**STEAMBOAT AIRPARK SUBDIVISION
CONSTRUCTION DRAWINGS**

**GLORIA GOSSARD PARKWAY
STEAMBOAT SPRINGS, CO 80487**

DRAWING:
CROSS SECTIONS #2

SHEET #
C6

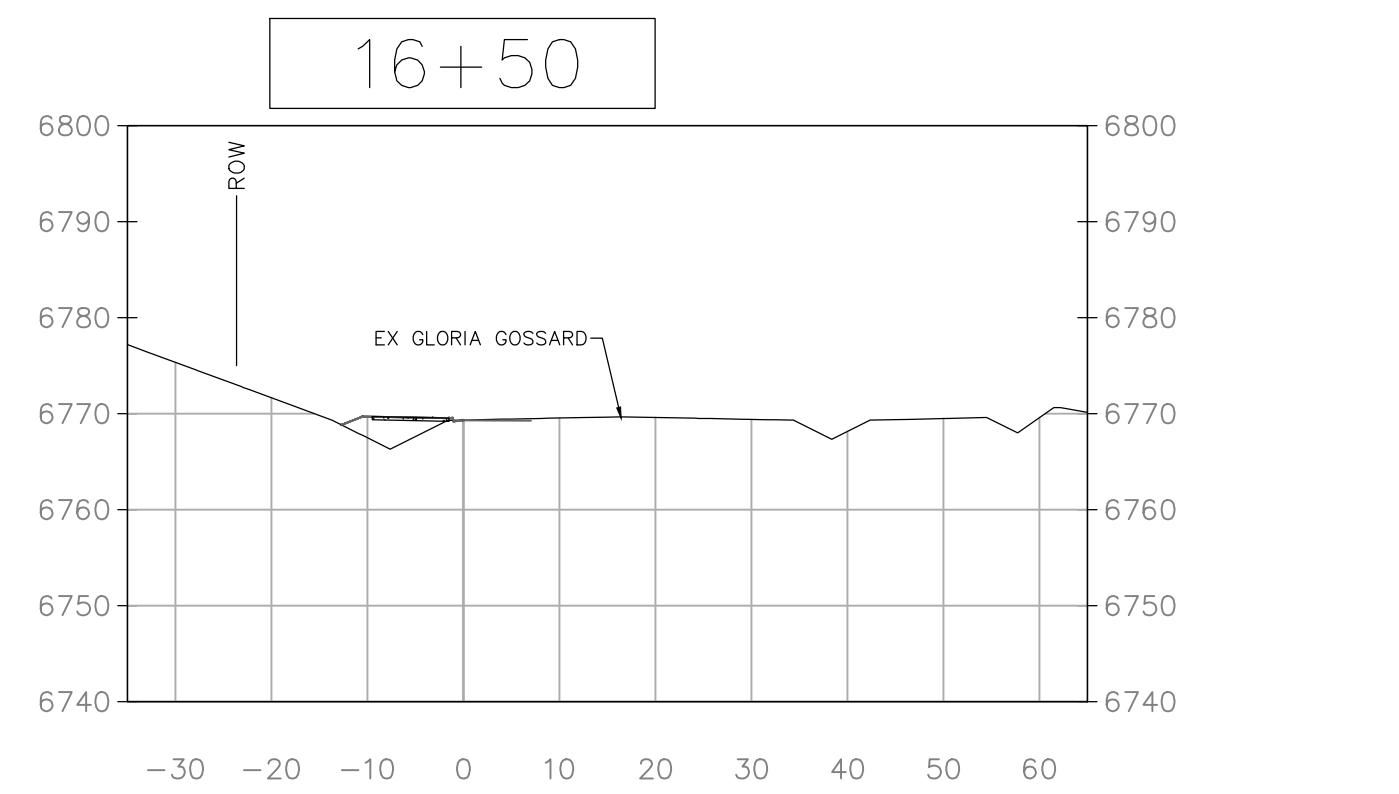
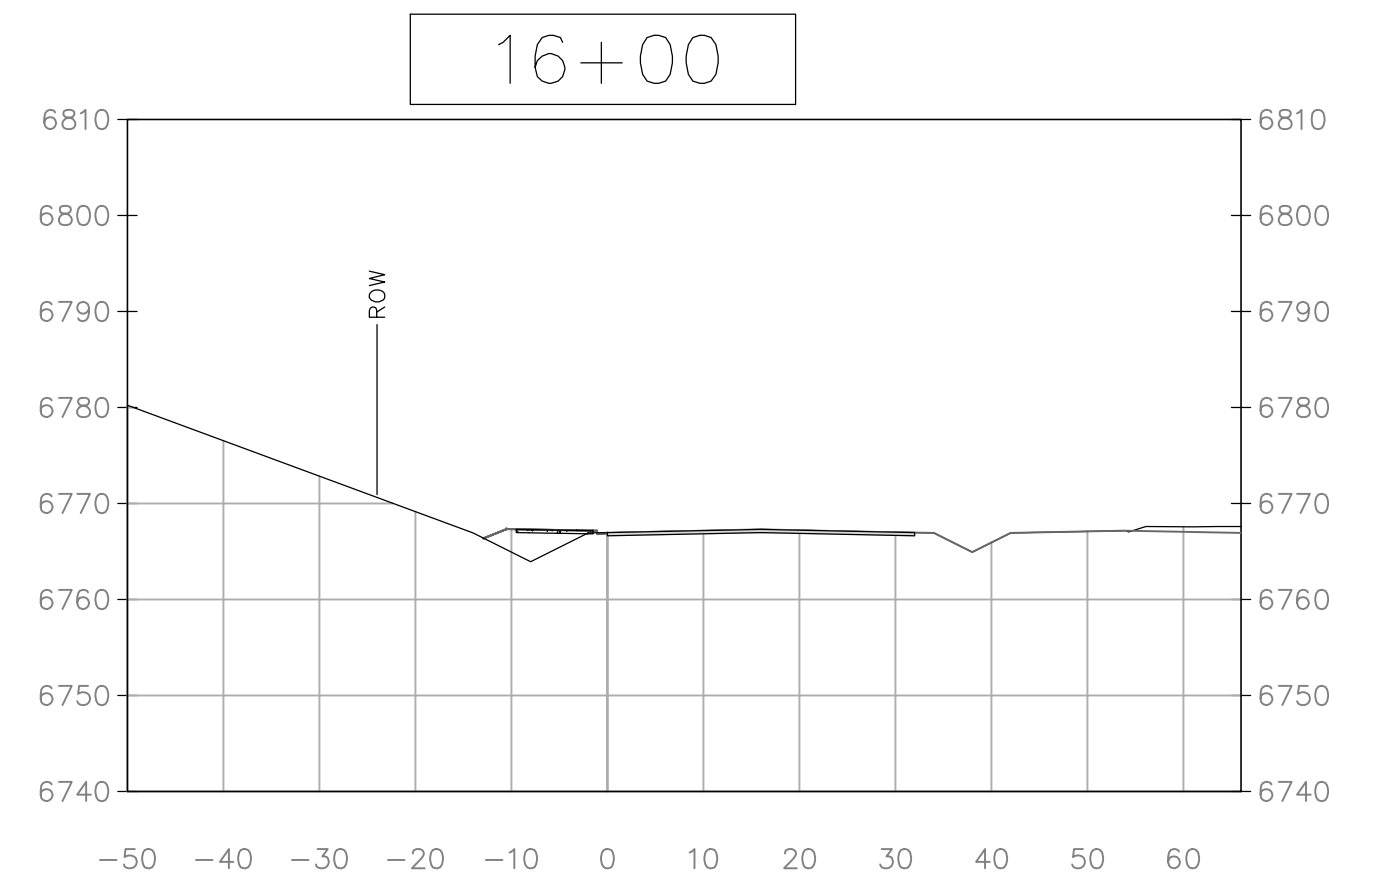
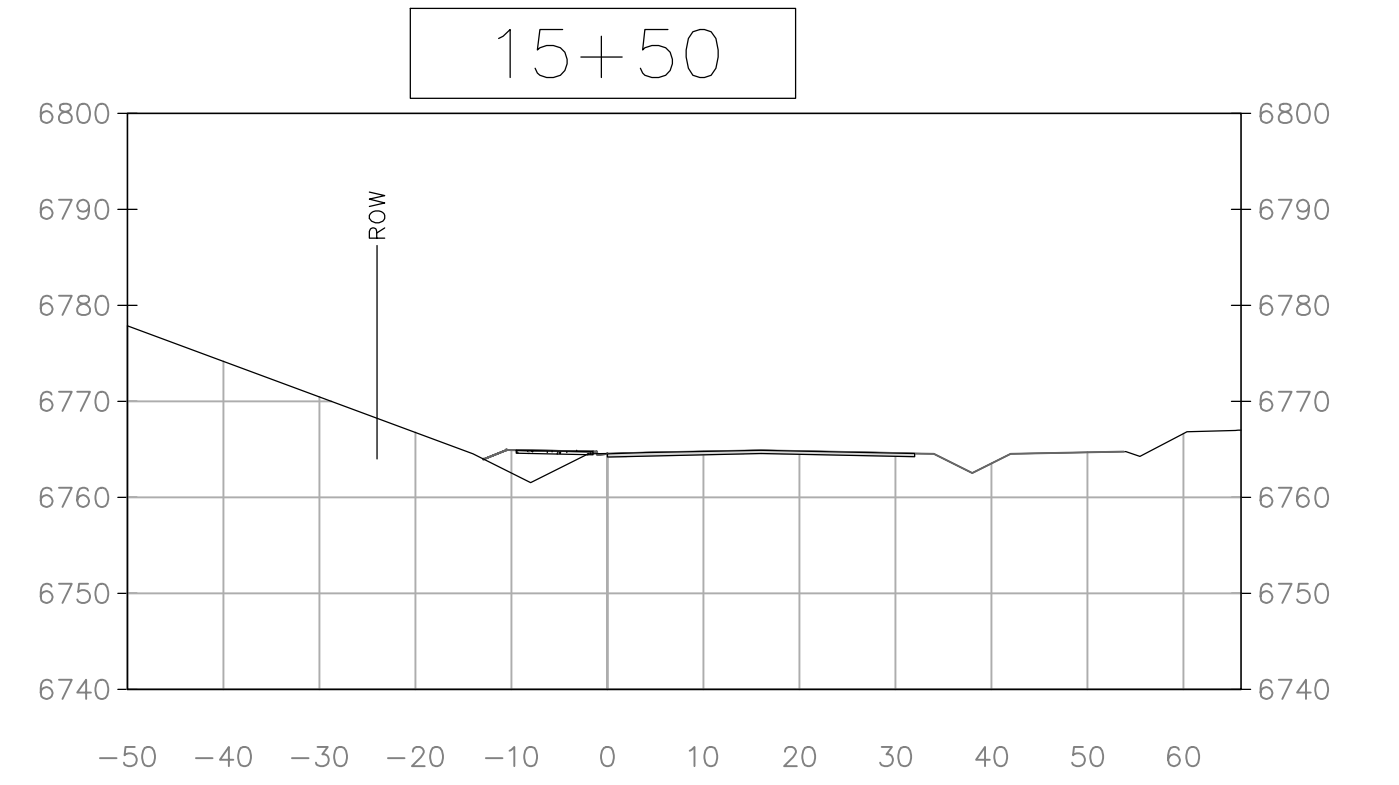
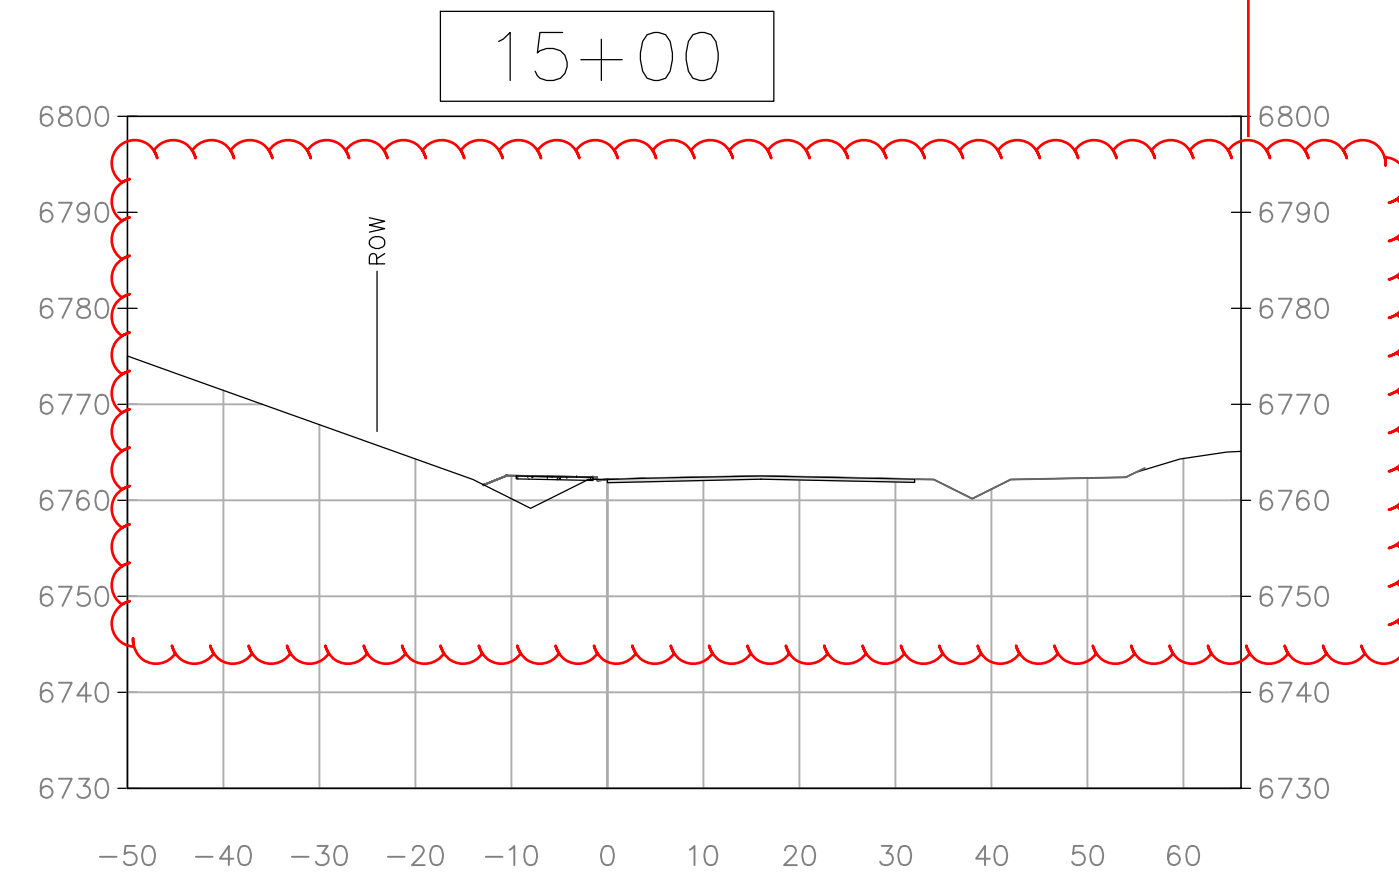
C6: Provide adequate labels for all cross-sections.

C6: Cross-section should be all the same size to be legible and provide adequate detail for the contractor to construct per plan
